Harmony Education Foundation Replat "A"

City Plan Commission — April 9, 2026

CASE NUMBER/TYPE:	SUSU25-00108 – Resubdivision Combination
CASE MANAGER:	Alonso Hernandez, (915) 212-1585, HernandezJA5@elpasotexas.gov
PROPERTY OWNER:	Harmony Public Schools
REPRESENTATIVE:	CEA Group
LOCATION:	North of Sun Valley Dr. and West of Dyer St. (District 4)
PROPERTY AREA:	1.60 acres
VESTED RIGHTS STATUS:	Not Vested
PARK FEES:	Not Required
ZONING DISTRICT(S):	A-3 (Apartment)

Figure A: Proposed plat with surrounding area

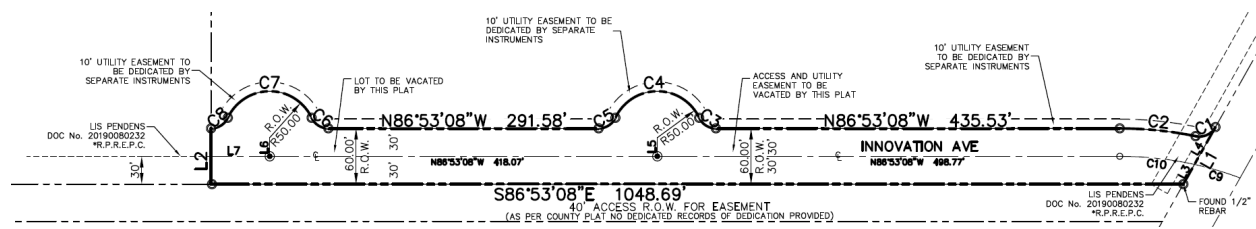
1. To allow the cul-de-sac street to exceed the maximum length of 300 feet.

EVALUATION OF EXCEPTION REQUEST: The applicant is requesting exceptions to Innovation Ave. under 19.15.090 – Cul-de-sac streets.

EVALUATION OF EXCEPTION REQUEST: The applicant meets criteria under 19.48.030 – Criteria for approval, which state that granting the waiver or exception will not be detrimental to the public health, safety, or welfare, or injurious to other property within the area; that granting the waiver or exception will not have the effect of preventing the orderly use and enjoyment of other land within the area in accordance with the provisions of this title, or adversely affect the rights of owners or residents of surrounding property; or that the request for a waiver or exception is not based exclusively on the applicant’s desire for increased financial gain from the property, or to reduce an existing financial hardship. Per Chapter 6.1.4 Maximum Length of a Cul-De-Sac Street of the Street Design Manual, Additional modifications may be required by the City Plan Commission upon recommendation by the fire marshal’s office including intermediate turnarounds (eyebrows) to accommodate emergency vehicles being provided at a maximum distance of six hundred feet or whichever is less. Fire Department does not object to this resubdivision.
